**Proposal for Harmonisation of South East England
Transition Altitude & Re-designation of Daventry Class C
Airspace (Known as "SE England TA")**

**STAKEHOLDER CONSULTATION
FEEDBACK REPORT**

**Issue 1
30 August 2011**

Figure 4 SE proposed configuration

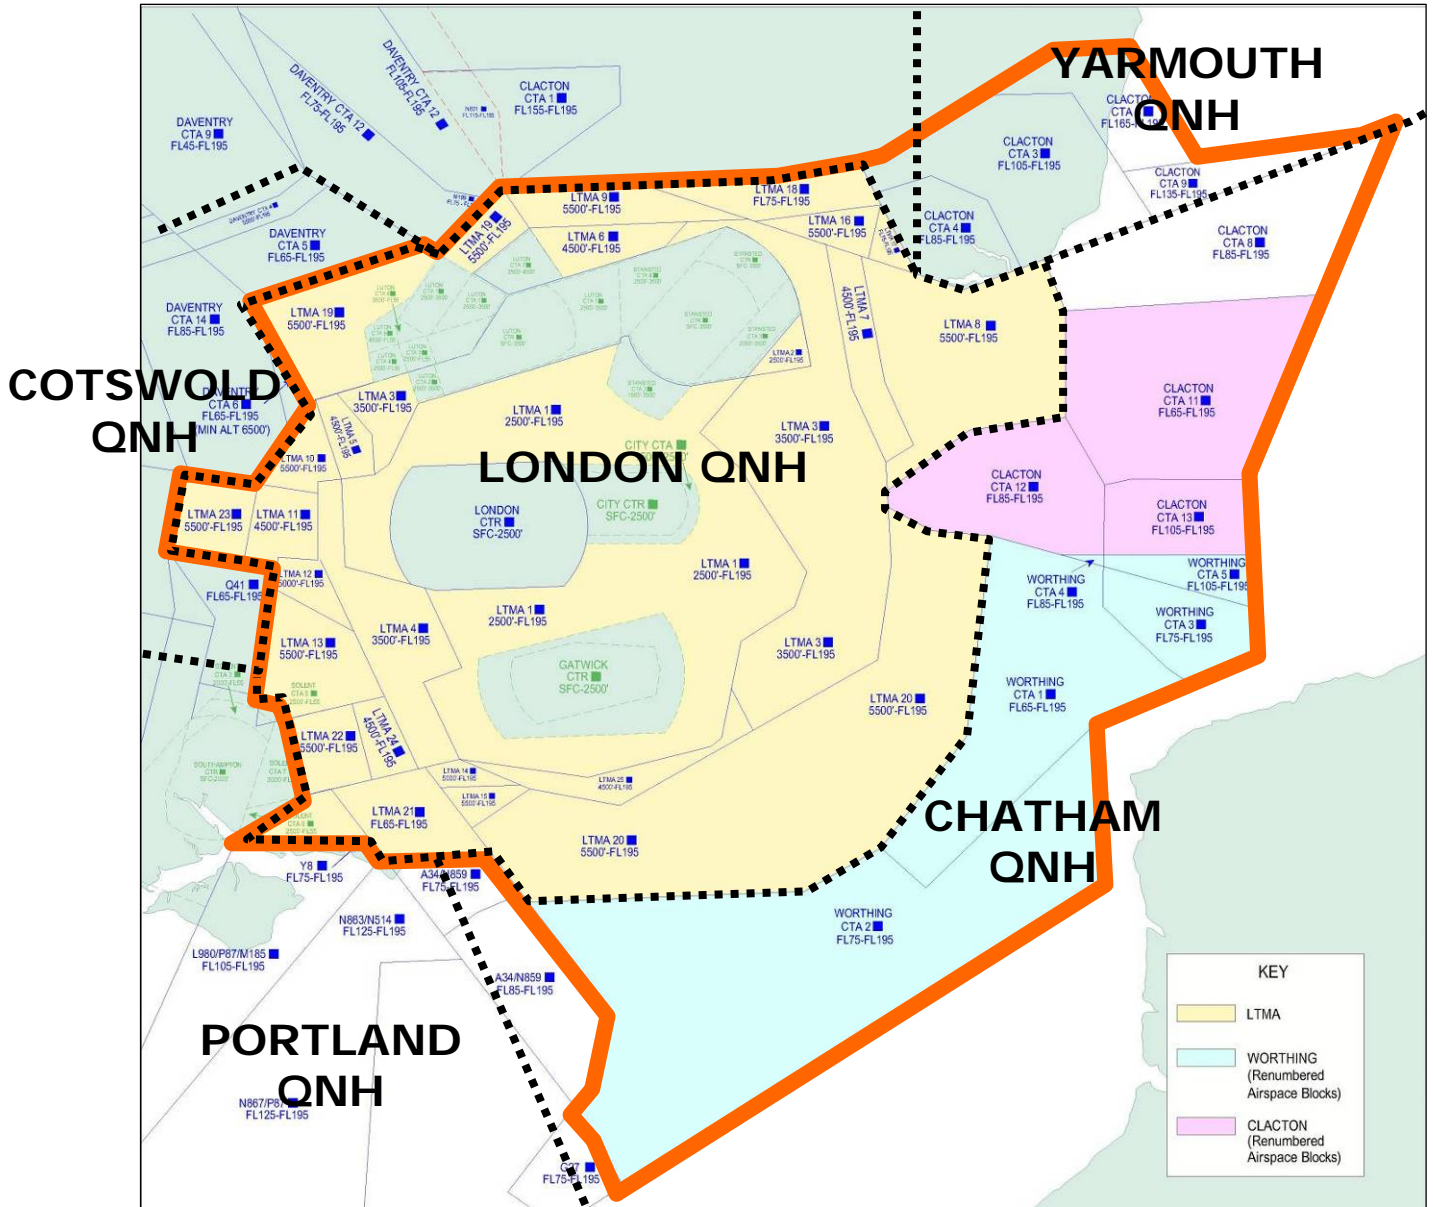
The BGA, BHPA & LAA expressed concern regarding “headroom reduction during periods of high pressure”. The issue is that at present since the base of controlled airspace (CAS) is defined as a flight level, the effective ceiling of uncontrolled airspace (UCAS) rises & falls depending on variations in atmospheric pressure. In high pressure conditions this can result in the ceiling of uncontrolled airspace being significantly higher. This can give glider pilots more “headroom” i.e. they can climb slightly higher which gives more gliding range. By changing the definition of the controlled airspace base to an altitude, the height of the boundary between controlled & uncontrolled airspace becomes fixed, it no longer varies with atmospheric pressure. Hence the request from the BGA, BHPA & LAA is that the base of CAS should not be changed to the corresponding altitude (i.e. FL55 becomes 5500ft) but it should be raised e.g. FL55 becomes 6000ft.

The LAA also cited that this change results in an increase in the length of boundary between the areas of 3000ft TA and 6000ft TA. It is at this interface that there is the opportunity for error, by operating with the wrong altimeter setting in either region. While it is true that the length of the boundary will be increased, it is intended that this will only be temporary until 2013/2014 at which point the TA will be unified in both controlled and uncontrolled airspace.

It is important that the TA harmonisation proposed herein is viewed in the context of the bigger strategic picture. The change proposed by this ACP is limited to harmonising the Transition Altitude at 6000ft. The next step proposed is to raise the transition altitude nationally to a higher level² (e.g. 18000ft). This would enable a redesign of all Standard Instrument Departures (SIDs) such that they could be (where possible) given unrestricted climbs. This has significant environmental benefits in terms of reduced CO₂ emissions and fuel burn. This should also result in the aircraft being higher sooner, and hence will enable a review of all the airspace bases. Such a review is planned as part of the London Airspace Management Programme (LAMP).

Hence although in the short term the issue of reduced headroom is valid, this change will in the long term enable the base of CAS in some areas to be raised. This will benefit all users of uncontrolled airspace.
